**DEQ Coal Combustion Residuals
Surface Impoundment
Closure Determination**

Roxboro Steam Station

April 1, 2019

Figure ES-1: Roxboro Steam Station October 2017 CSA Update Report

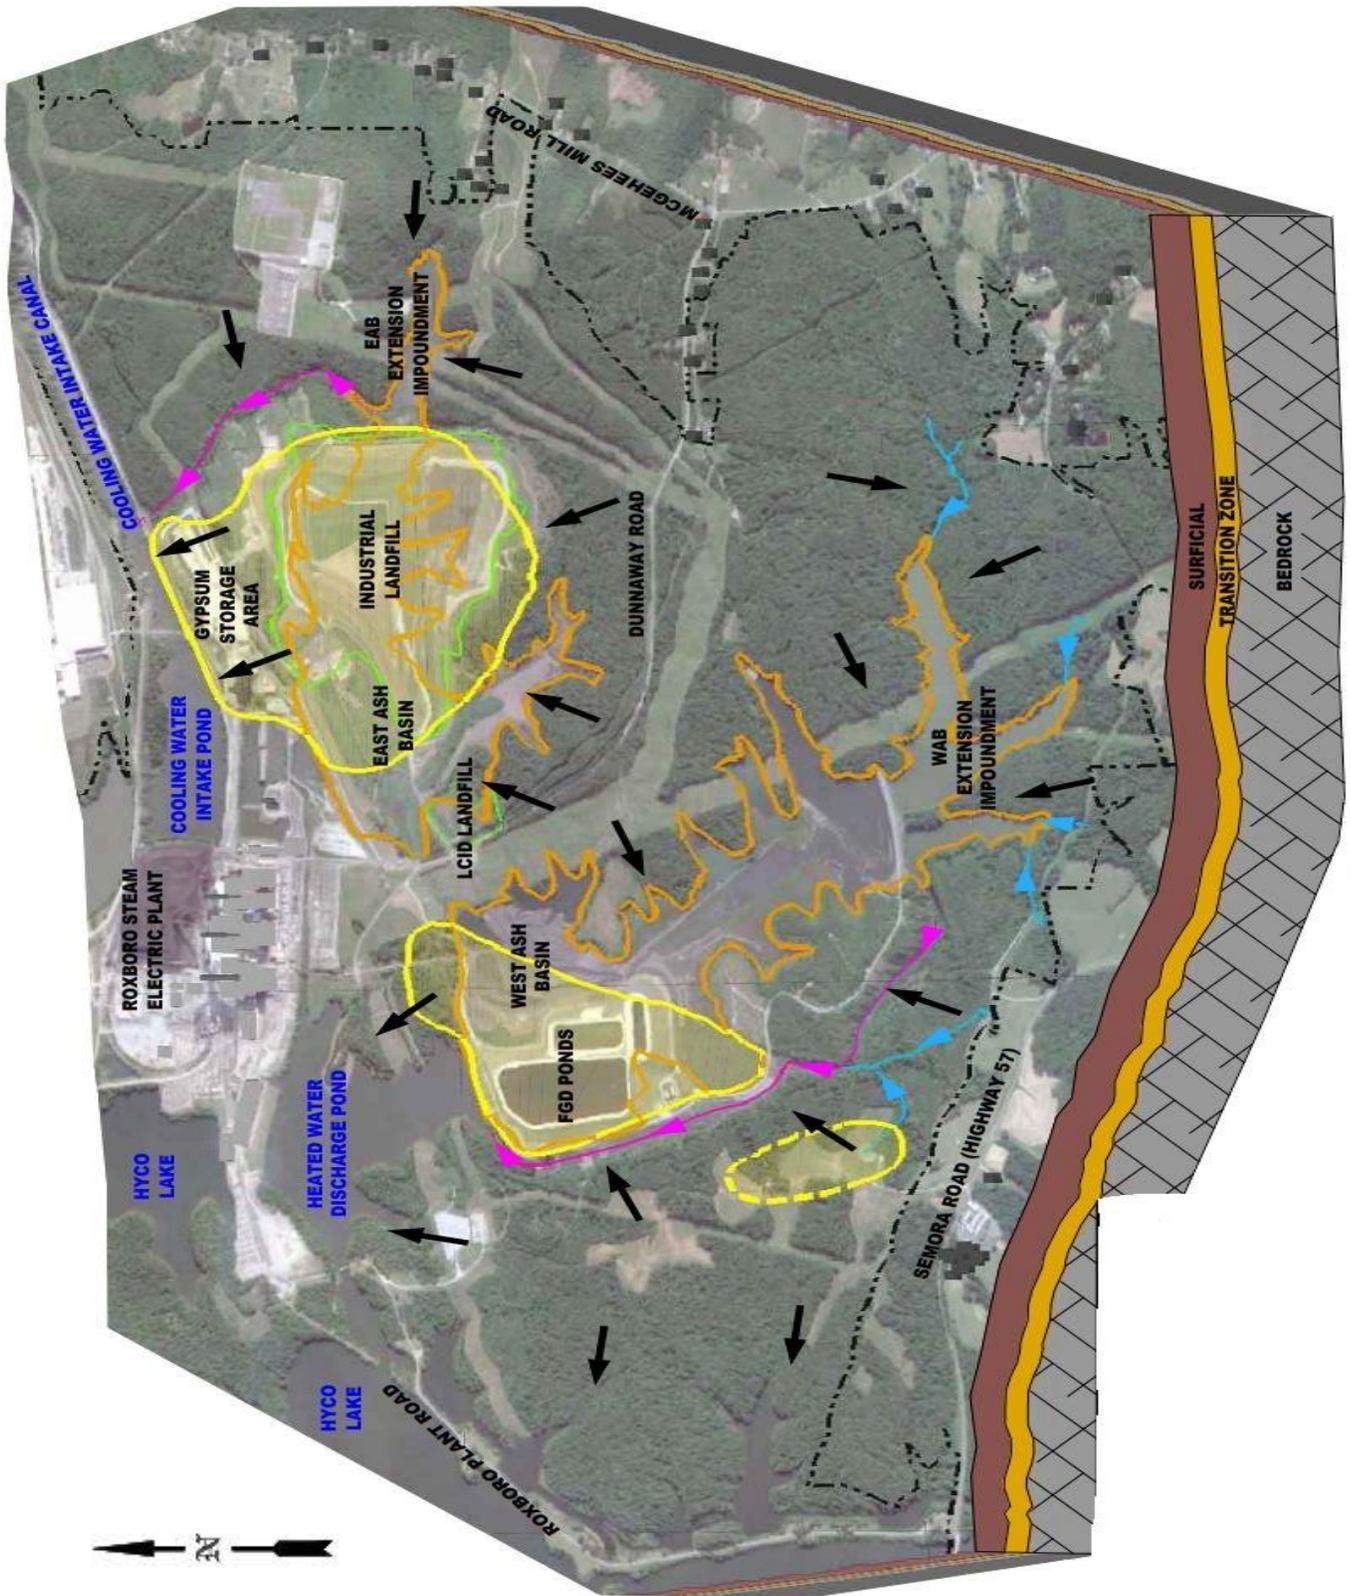
DEQ concludes that the contaminated groundwater plume above 2L standards has extended beyond the compliance boundary along the northern edge of the impoundment. Based on Figure ES-1, this plume extends along the majority of the length of the EAB.

CROSS SECTION A-A' (VIEWED FROM NE SIDE OF CROSS SECTION LOOKING TO SW)

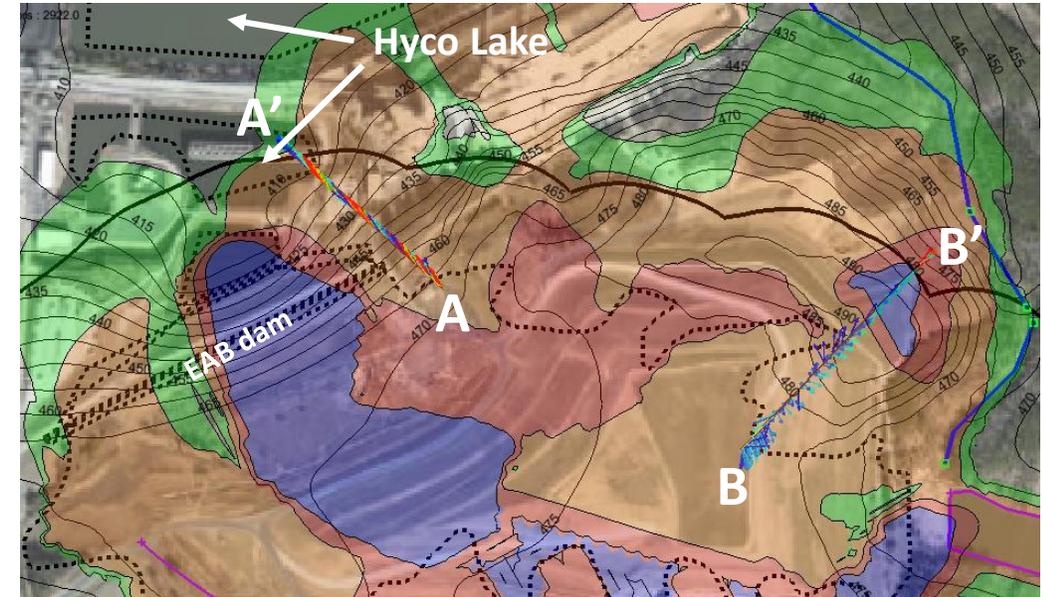
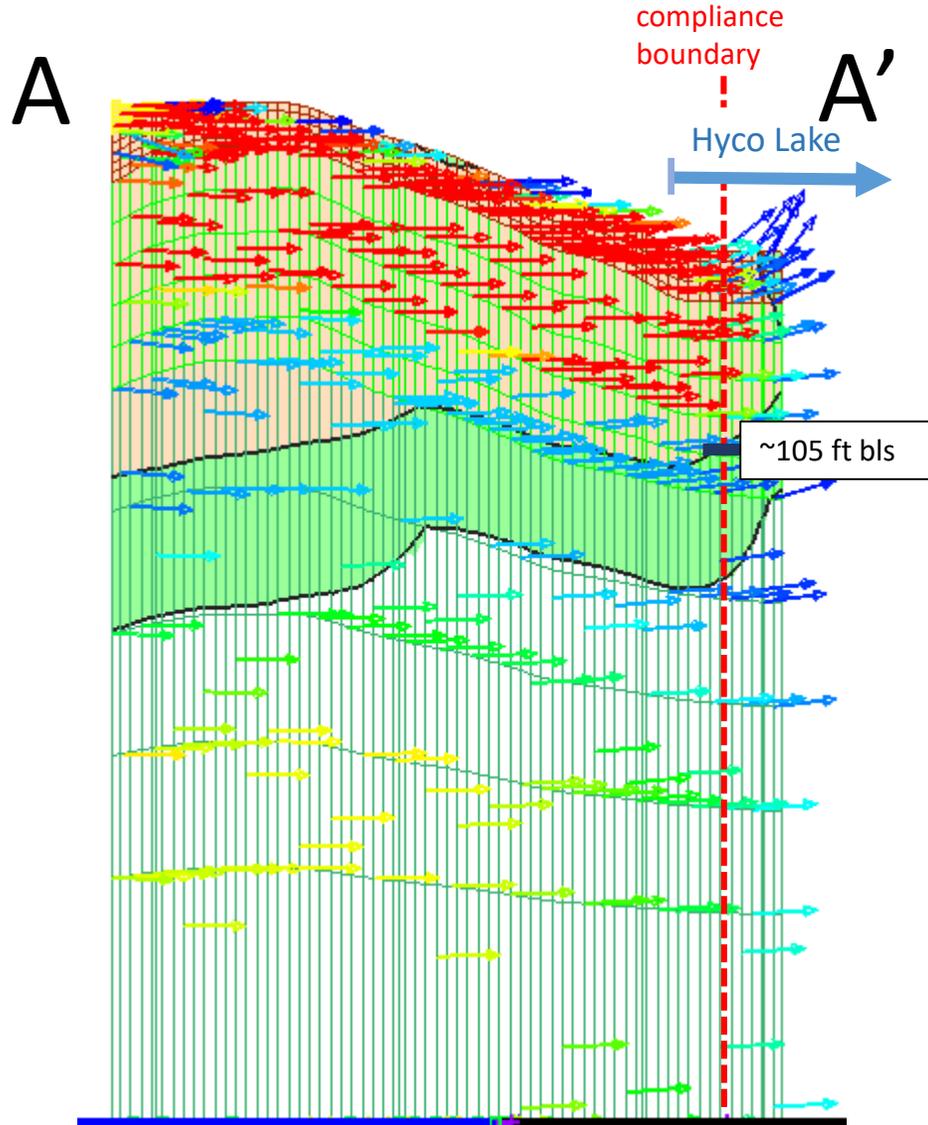
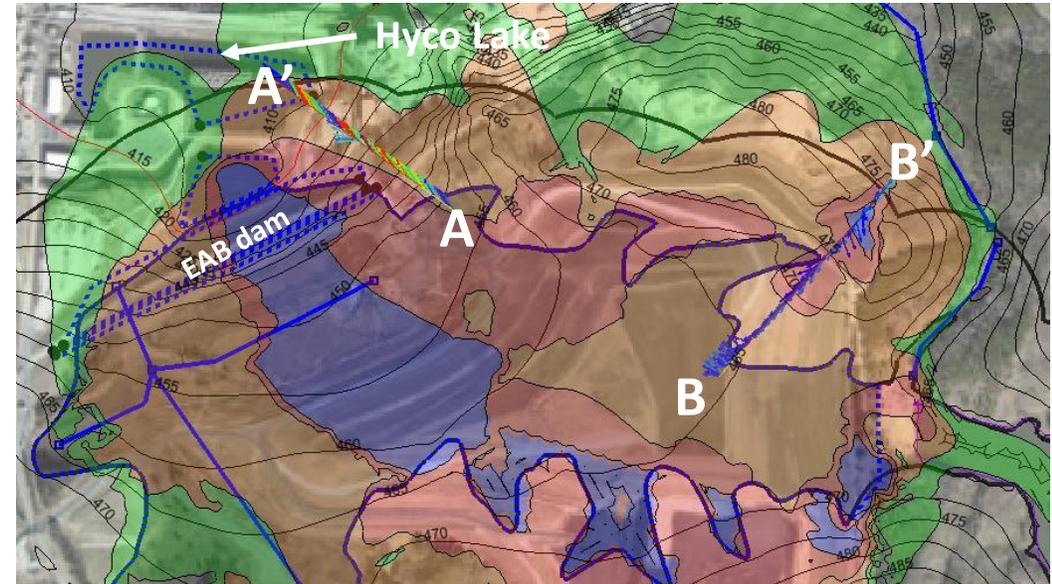
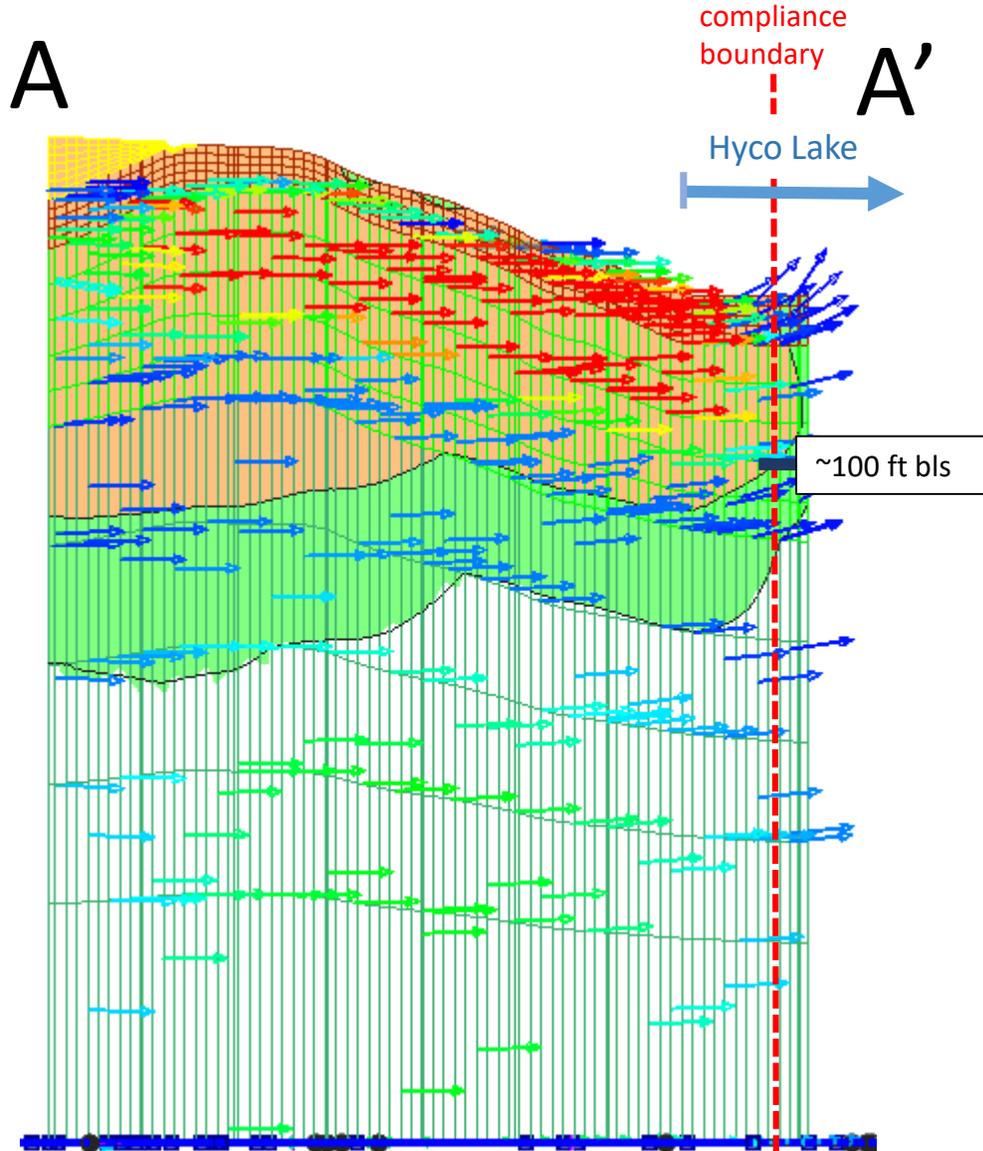
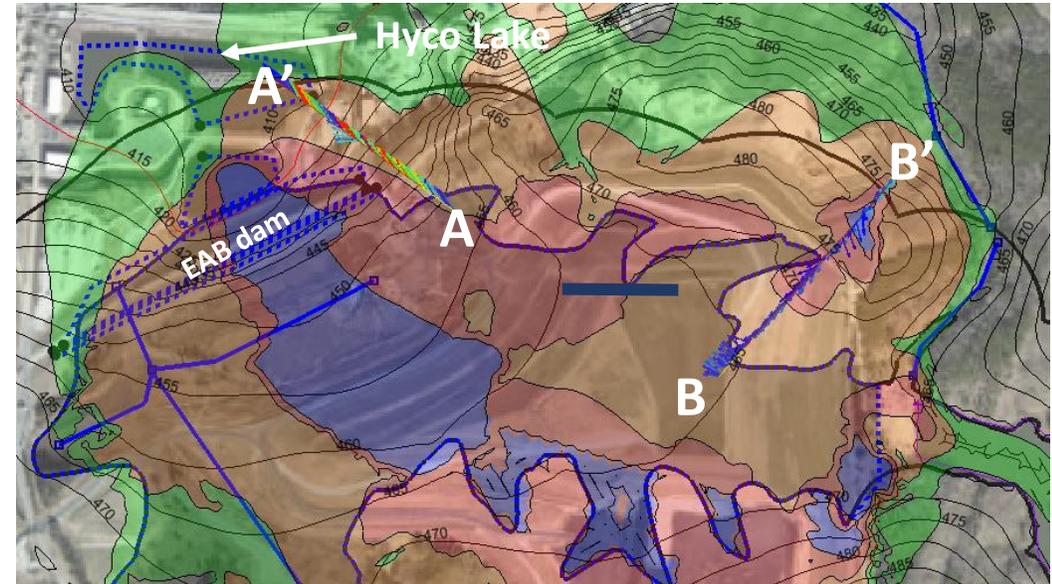
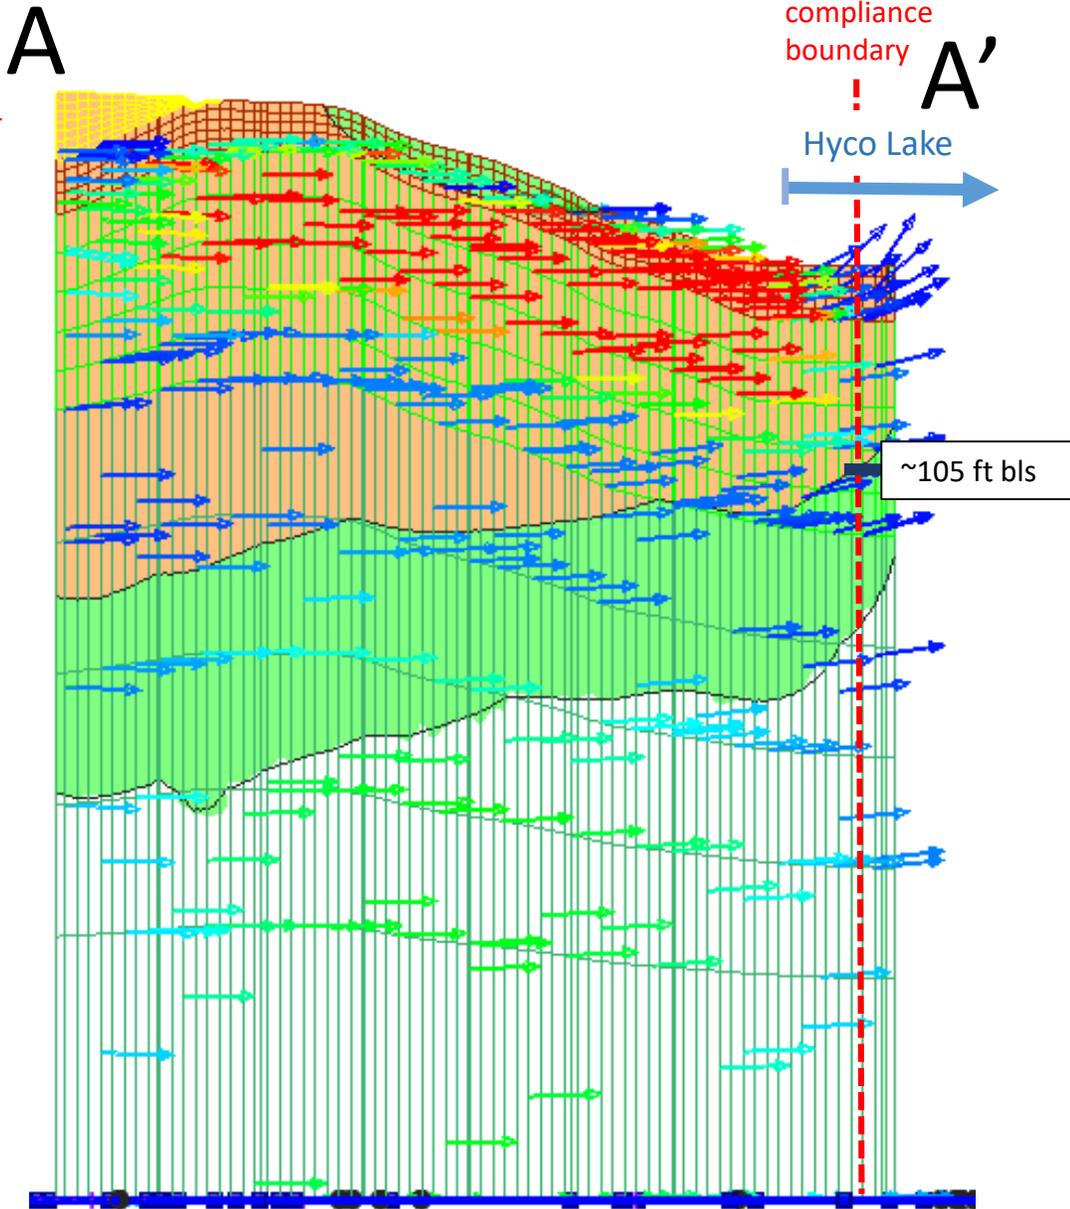
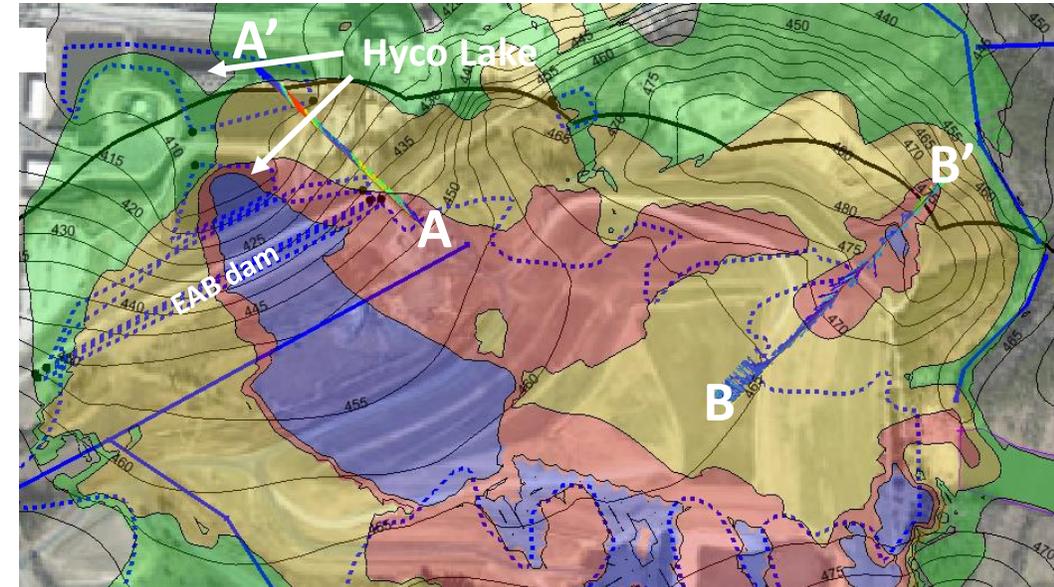
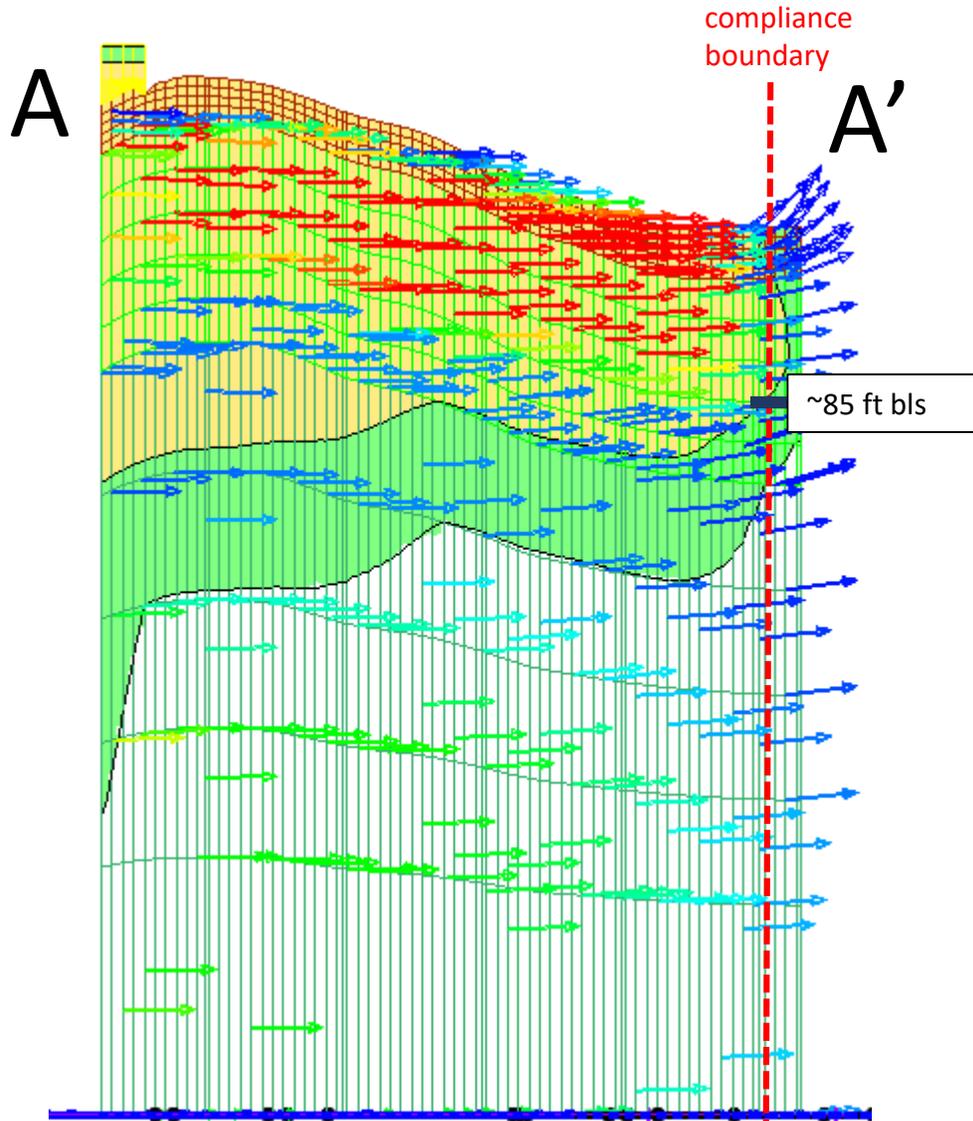
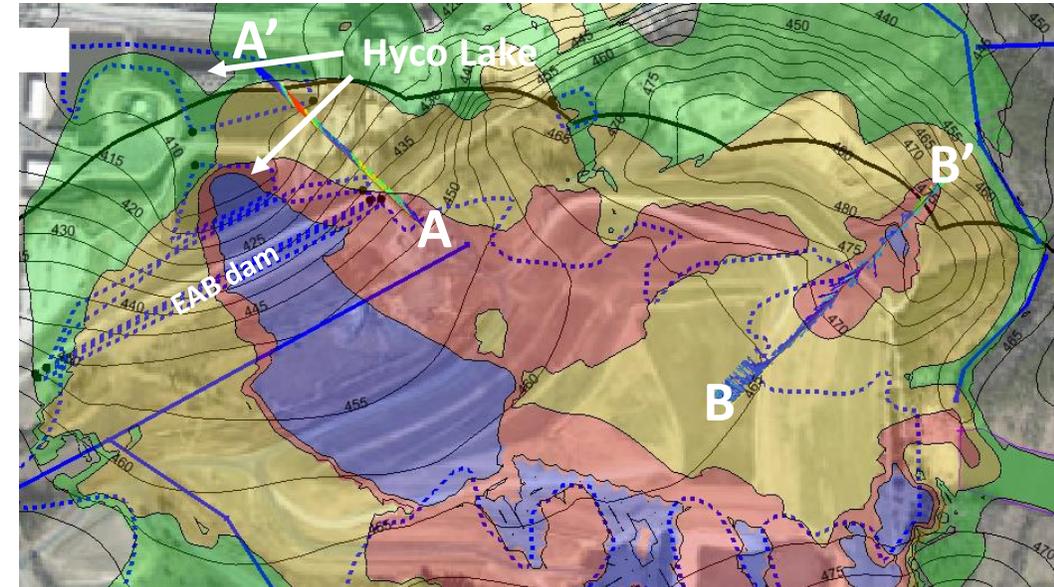
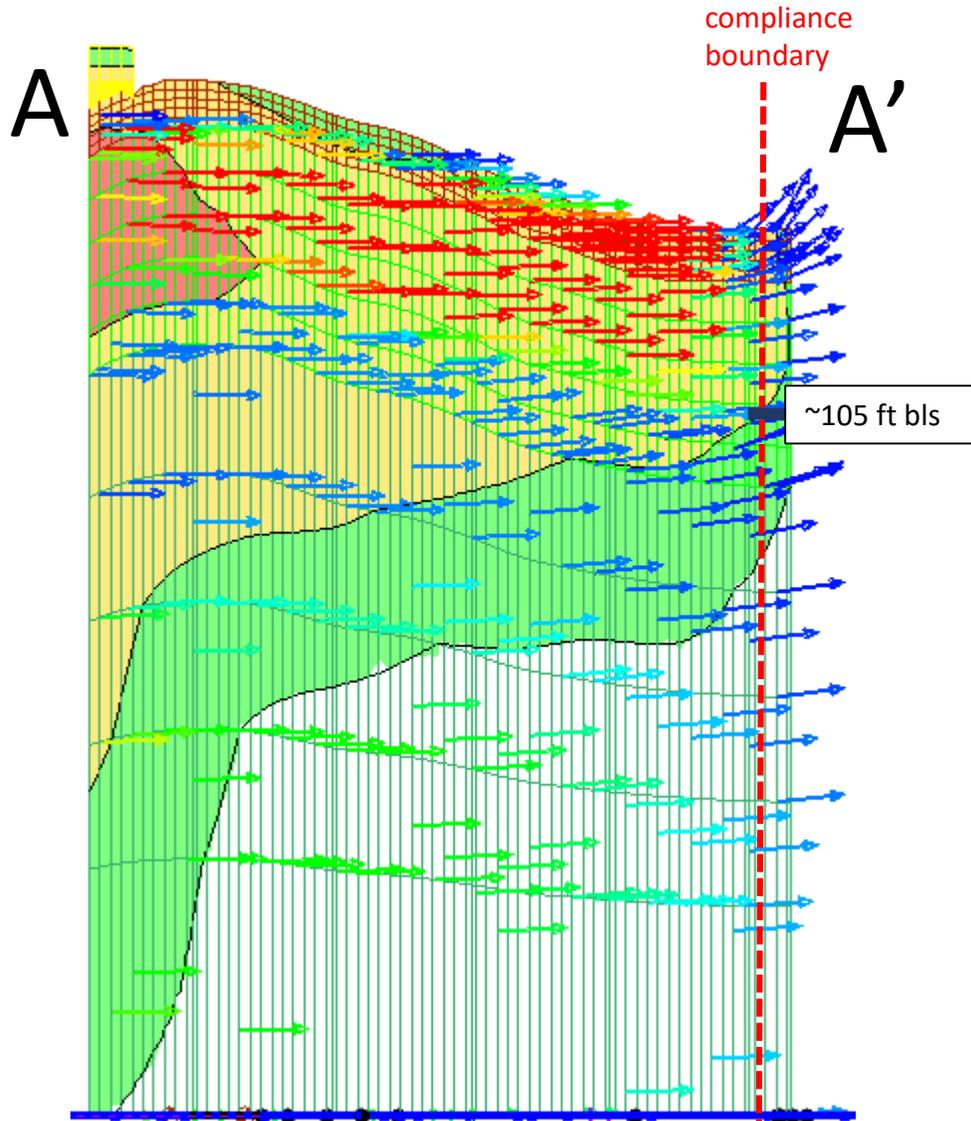
Roxboro Modeling Results for Cross-Section A-A'			
Model Simulation	Maximum Concentration of Boron Above 2L Beyond Compliance Boundary (ug/L)	Depth of GW Contamination Above 2L Beyond Compliance Boundary (feet bgs)	Width of Contamination Plume Beyond Compliance Boundary (feet)
Current Conditions	700-4,000	105	660
Completion of Final Cover (t=0 yrs)	700-4,000	100	670
Final Cover (t=100 yrs)	700-4,000	105	300
Completion of Hybrid (t=0 yrs)	700-4,000	85	670
Hybrid (t=100 yrs)	700-4,000	105	400

These data illustrate that after completion of closure with the final cover or hybrid option, the groundwater plume still extends beyond the compliance boundary above the 2L groundwater standard and the area of the plume requiring remediation is immense. Even 100 years beyond completion of closure, the area of the plume requiring remediation remains extensive.

DEQ recognizes that there are no groundwater remediation corrective actions included in the groundwater modeling simulations submitted to DEQ as part of Duke Energy's closure options analysis documentation. However, based on the current geographic scope, vertical extent of the groundwater contamination plume, and future modeled extent of the plume, DEQ does not believe these two closure options for the EAB can meet the requirements of CAMA Option B.
